Subject: Approval of Change Order No. 1 with Dan Hart Patrol Service, LLC for the Landfill Cell No. 7 Project No. 2112, for an increase of \$440,156.56, for a new contract price of \$2,233,491.38.

CHANGE ORDER NO.: 1

Owner:	City of Watertown	Owner's Project No.:	2112
Engineer:	Houston Engineering Inc.	Engineer's Project No.:	7716-0020
Contractor:	Dan Hart Patrol Service, LLC.	Contractor's Project No.:	
Project:	WRLF Cell 7 Construction

Watertown Regional Landfill Cell 7

A LEACHATE COLLECTION TRENCH
22 NOT TO SCALE

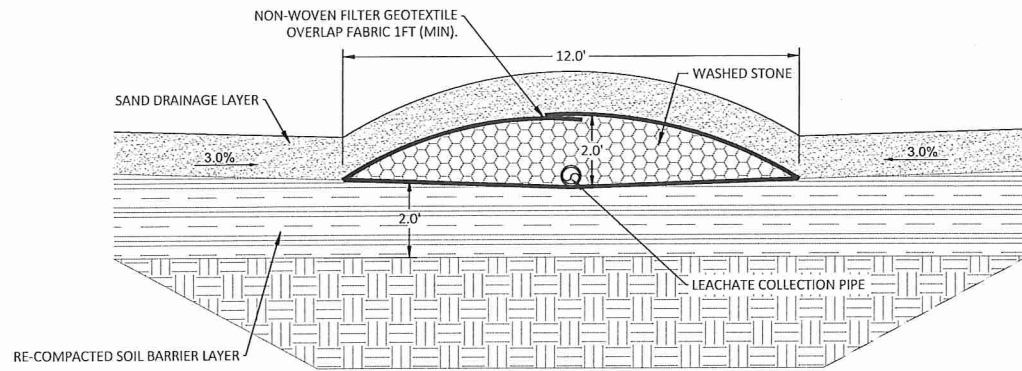
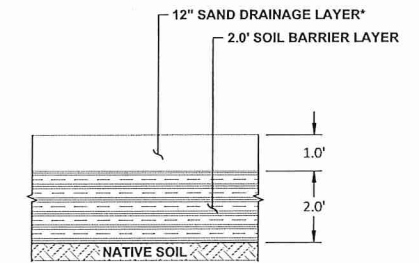
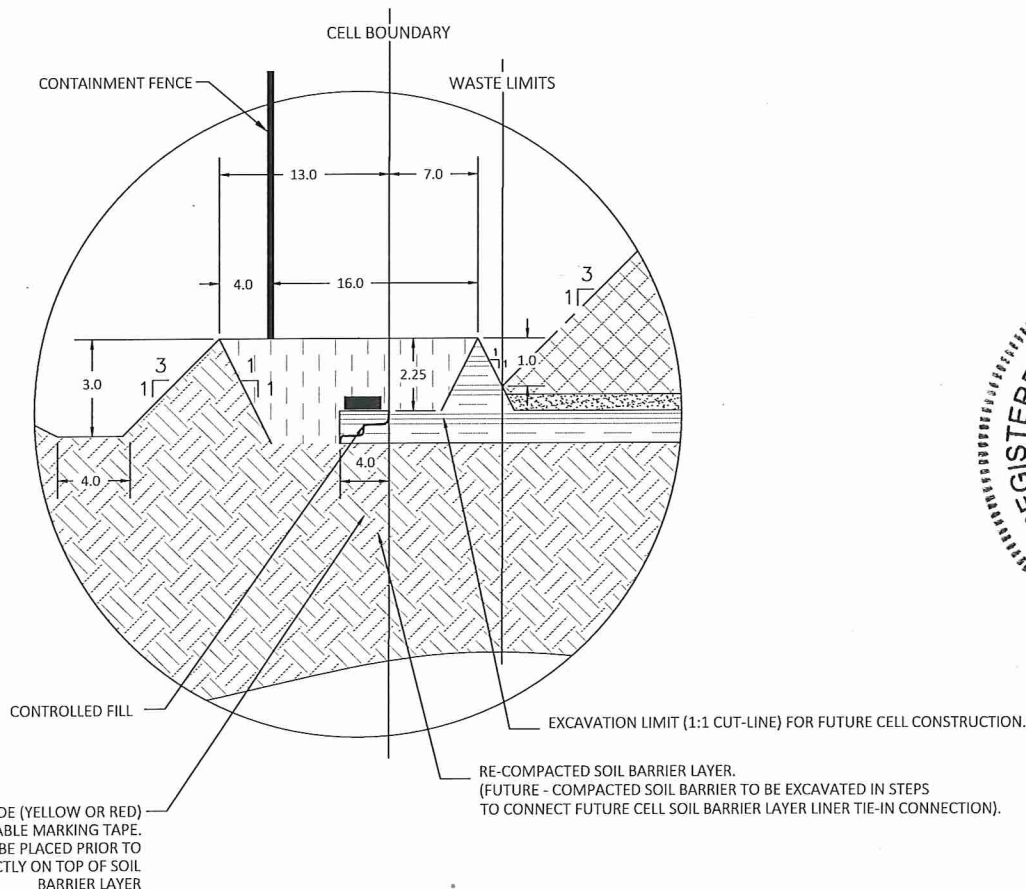
Drawing(s) / Details (s): Plan Sheet 7 – Leachate Collection Pipe denoting revised Cell 7 grades
Plan Sheet 16 – Point Schedule denoting revised Cell 7 grades
Plan Sheet 22 – Liner Details revising leachate collection trench

To maximize the separation distance from the bottom of the base liner and the fill materials within the unsuitable material removal/replacement area the leachate collection trench has been modified. The revised plan identifies removal of the 2-foot depression to install the trench. The trench (geotextile/pipe/rock combination) will be placed atop the channel created via the intersection of the western and eastern slopes (3% inward) at the middle of the Cell.

1	REVISED CELL 7 BASE GRADES PER FO-03/CO-01	6-8-2022	AMZ	I hereby certify that this plan, specification, or report was prepared by me or under my direct supervision, and that I am a duly Licensed Professional Engineer under the laws of the State of South Dakota.
No.	Revision	Date	By	Dennis D. McAlpine License No. 13753
